# Laneside Barn, Grindleton – Addendum to the Structural Inspection for Planning

**Description:** For client and planning approval

**Project:** Laneside Barn  
**Client:** Mr. Keith Lee  
**Description:** Addendum to: Structural Inspection  
**Date:** 4<sup>th</sup> December 2024

Figure 1: Site layout and nomenclature of the main barn and additional structures.

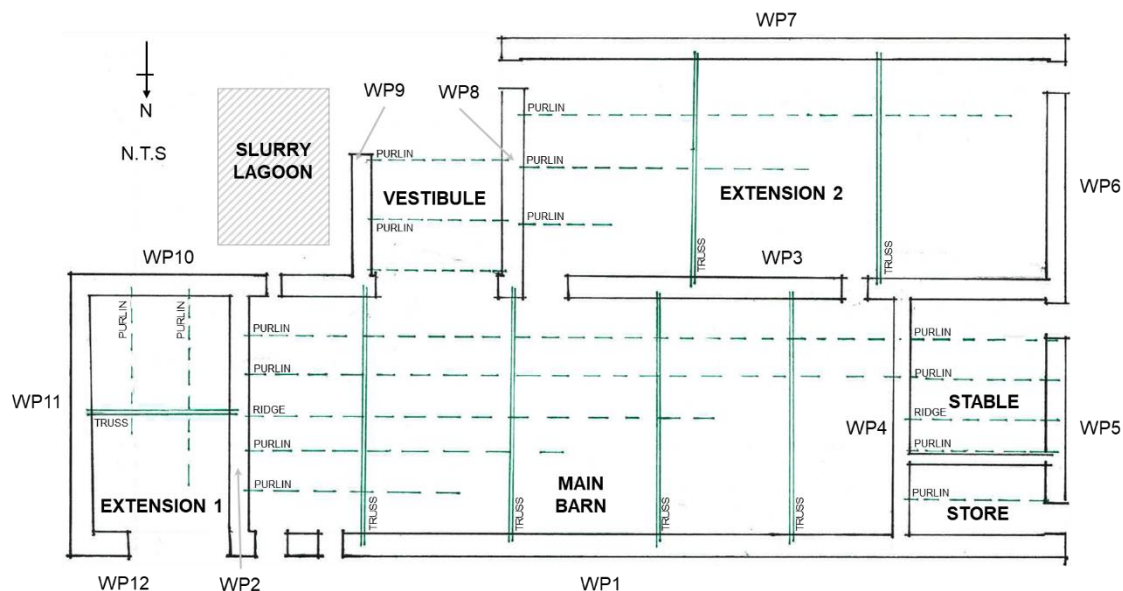
We have received an updated set of planning drawings which indicate that Extension 1 is no longer under consideration for conversion and is to be demolished. The structural stability of Extension 1 is therefore not of concern.

WP 7 has suffered from a shallow foundation which has been wet for a long period of time due to the lack of guttering to the large roof area directly above. The water discharging onto the ground here will have softened the soils, allowing the wall to settle at its outer edge by a small amount. The settlement of the outer portion of the wall relative to the inner portion sets up a rotational type of movement which has manifest in an outward lean which was most pronounced at its eastern end.

During the inspection, a maximal outward excursion of 75mm was estimated with a plumb bob and measuring tape. By conservative engineering theory for materials such as masonry, a freestanding (unrestrained) solid wall may deviate up to one sixth of its thickness before it is considered unstable – a manifestation of the ‘middle third rule’ for compressive structural elements. A cavity or other construction such as a rubble fill type wall (such as WP7) would reduce this limit slightly, and WP7 exceeds this limit.

If a wall is restrained against further movement (i.e. no longer considered to be freestanding), an often-quoted rule of thumb for structures of this nature is that 50 – 85% of the walls thickness is an acceptable and stable bulge, if the wall can be restrained<sup>1</sup>. Suitable restraint can be arranged by means of a firm connection to the roof structure and where necessary by some posts framing the proposed opening and concealed in the new construction to tie back to at the opening.

The requirement to retain WP7 that has come to light through the planning process materially alters this balance and we have therefore altered our recommendations to support the proposed scheme and maintain our recommendation that the structure remains suited to conversion. The following paragraphs are provided to justify these recommendations.

With the existing wall stabilised, the issue of the shallow foundation and the (likely) softened soils upon which they bear must be addressed. For this we recommend some localised underpinning at the eastern end of the wall, and some investigations into the ground conditions at the western end with a view to some additional underpinning locally if required.

Underpinning has successfully been undertaken to similar heavy masonry structures for decades. The underpinning would be carried out in the classical manner, excavating small bays by hand in a specified sequence, sized to suit the masonry characteristics and flooding with concrete to underpin. This underpinning would be undertaken prior to the formation of the proposed opening and would also require the careful propping / shoring of the eastern free end during excavations for the end bay.
